SUBJECT: AMENDMENT NO. 123 TO FACILITY OPERATING LICENSE NO. DPR-74:
(TAC NOS. 71481 AND 75261)

Donald C. Cook Nuclear Plant

3/4.4.9 PRESSURE/TEMPERATURE LIMITS

SAFETY EVALUATION BY THE OFFICE OF NUCLEAR REACTOR REGULATION
RELATED TO AMENDMENT NO. 123 TO FACILITY OPERATING LICENSE NO. DPR-74
INDIANA MICHIGAN POWER COMPANY
DONALD C. COOK NUCLEAR PLANT, UNIT NO. 2
DOCKET NO. 50-316

FIGURE 3.4-2

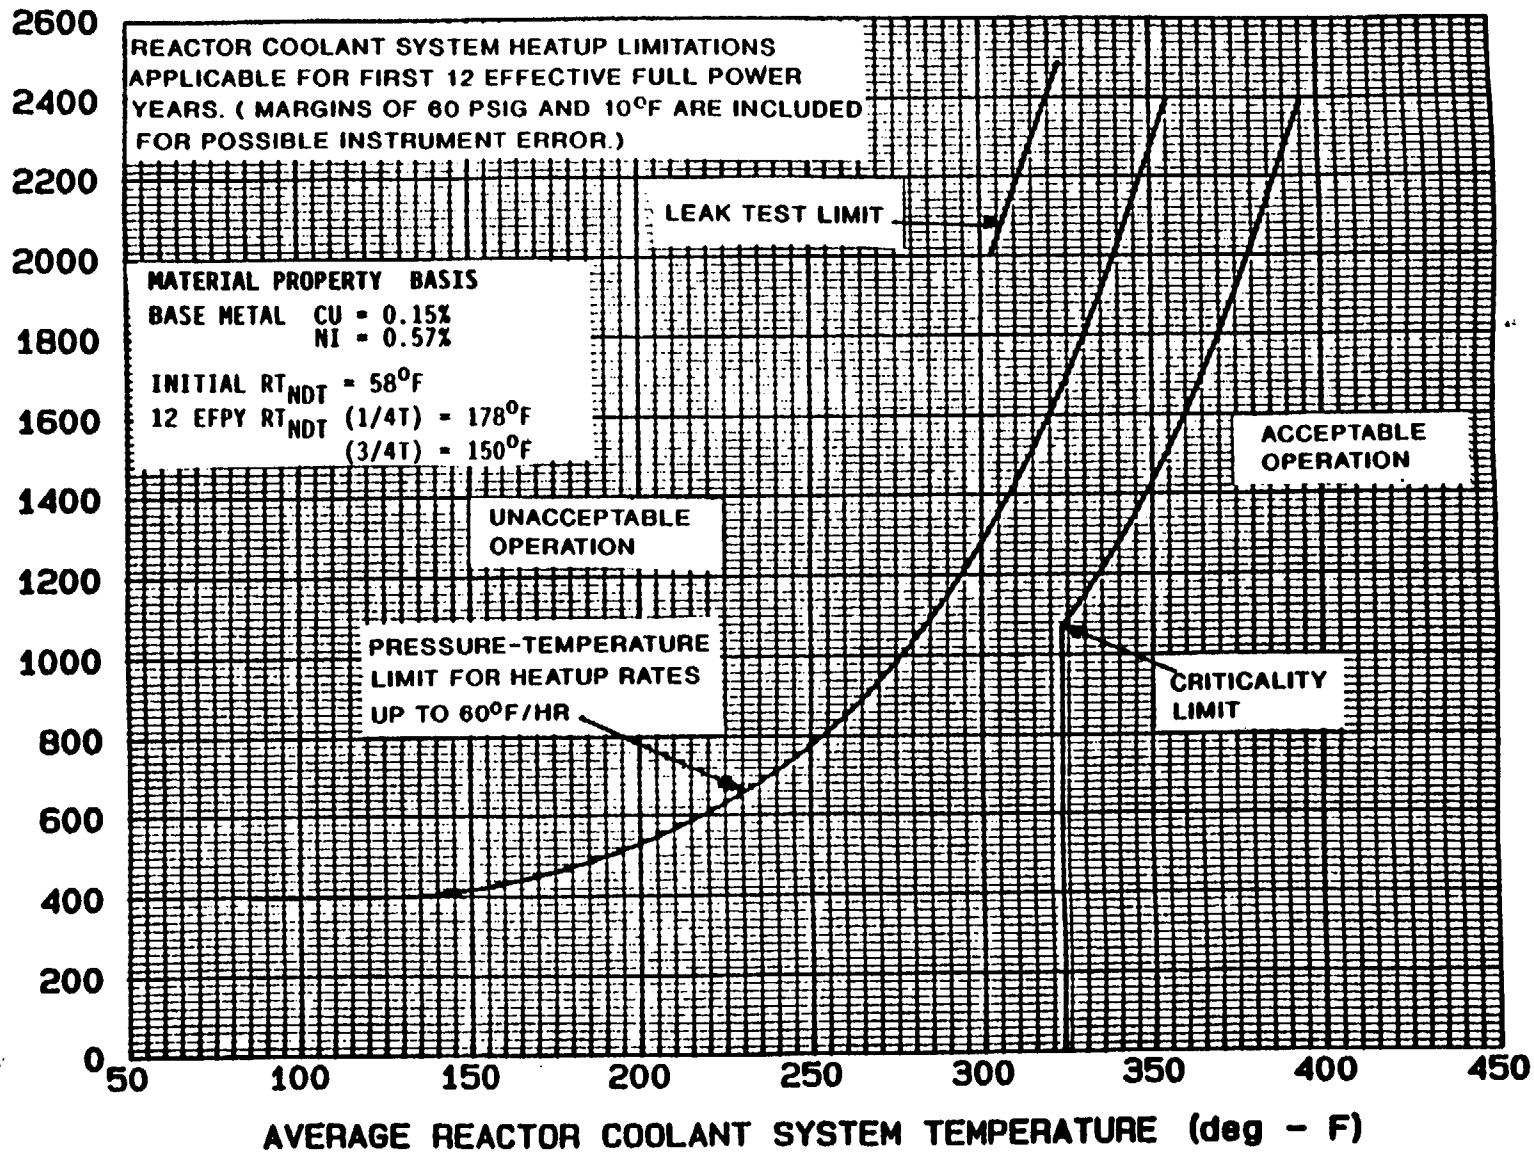
This amendment changes Technical Specification (TS) 3/4.4.9, "Pressure/Temperature Limits," to limit the maximum heatup rate to 60°F/hr and to provide revised heatup and cooldown pressure-temperature (P-T) limit curves. The maximum heatup rate is currently limited to 100°F/hr. The revisions are based on a reanalysis of reactor vessel sample material in accordance with Regulatory Guide (RG) 1.99, Rev 2. Through this licensing action the requirements of Generic Letter 88-11 have been satisfied for D. C. Cook, Unit No. 2

3.4.9.1 The Reactor Coolant System (except the pressurizer) temperature and pressure shall be limited in accordance with the limit lines shown on Figures 3.4-2 and 3.4-3 during heatup, cooldown, criticality, and inservice leak and hydrostatic testing with:

- a. A maximum heatup of 60°F in any one hour period.
- b. A maximum cooldown of 100°F in any one hour period.
- c. A maximum temperature of less than or equal to 5°F in any one hour period during inservice hydrostatic and leak testing operations above the heatup and cooldown limit curves.

The heatup limit curve, Figure 3.4-2, is a composite curve which was prepared by determining the most conservative case, with either the inside or outside wall controlling, for any heatup rate up to 60°F per hour. The cooldown limit curves of Figure 3.4-3 are composite curves which were prepared based upon the same type analysis with the exception that the controlling location is always the inside wall where the cooldown thermal gradients tend to produce tensile stresses while producing compressive stresses at the outside wall. The heatup and cooldown curves were prepared based on the most limiting value of the predicted adjusted reference temperature at the end of 12 EFPY.

The pressure-temperature limit lines shown on Figure 3.4-2 for reactor criticality and for inservice leak and hydrostatic testing have been provided to assure compliance with the minimum temperature requirements of Appendix G to 10 CFR 50.
